4. Skyline Heights Estates Kachemak Landing Airpark KPB File 2023-142 Seabright Surveying / Kachemak Landing, LLC Location: Near Sterling Highway & Aviation Way Diamond Ridge Area / Kachemak Bay APC

ITEM #4 - PRELIMINARY PLAT Skyline Heights Estates Kachemak Landing Airpark

KPB File No.	2023-142
Plat Committee Meeting:	January 8, 2024
Applicant / Owner:	Kachemak Landing, LLC / Homer, AK
Surveyor:	Katherine Kirsis / Seabright Survey + Design
General Location:	Diamond Ridge, Homer, Kachemak APC

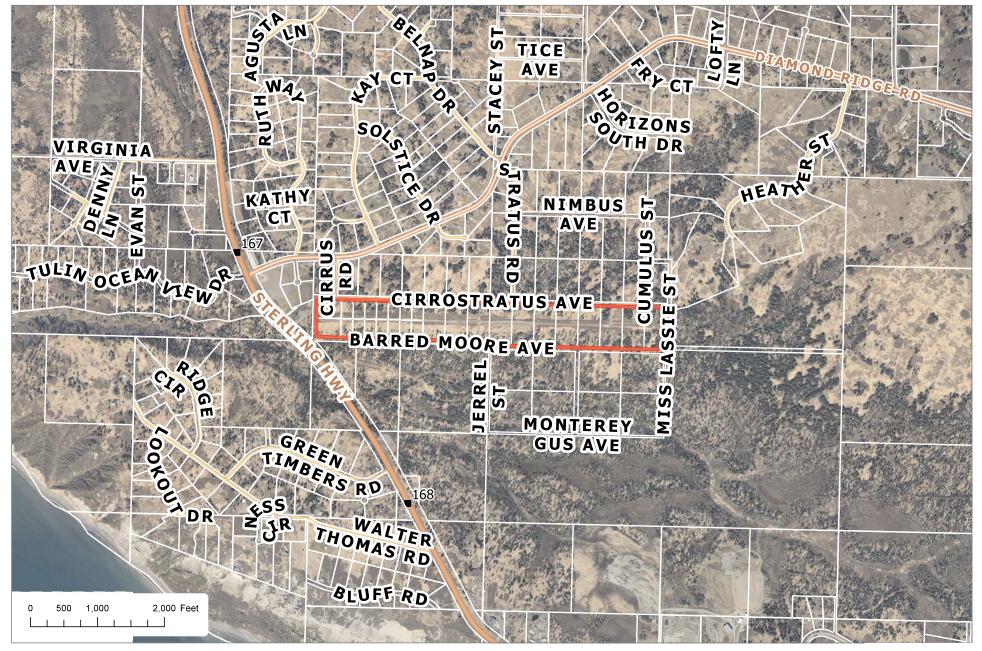
Check spacing in plat note #7 at the bk and pg.

Change KPB File No to 2023-142 Add plat names to the legal

Label Tract A as Private Airstrip.

Lot 24 to the north needs correct plat label.

- A. The bearing and length of every lot line, block line, and boundary line shall be shown. Dimensions of lots shall be given as net dimensions to the boundaries of adjoining streets and shall be shown in feet. No ditto marks shall be used. Information shall be shown for all curves, including radius, central angle, arc length, chord length and chord bearing. The initial point of survey shall be shown and labeled. All non-radial lines shall be labeled. If monumented lines were not surveyed during this platting action, show the computed data per the record plat information. Check the totals on the top and bottom of Tract A to the lot totals.

Give the measured and recorded data on the curves and in the lots that are remaining in width from the plat and only being shortened for Tract A.

There is recorded data for the west line also.

- Roads must meet the design and construction standards established by the borough in order to be considered for certification and inclusion in the road maintenance program (KPB 14.06).
- Carry forward plat note #5 from plat Tulin Skyline Heights Estates #2 HM 2008-90.

Staff recommendation: comply with 20.60.190. Add a Plat Approval with date of January 8, 2024
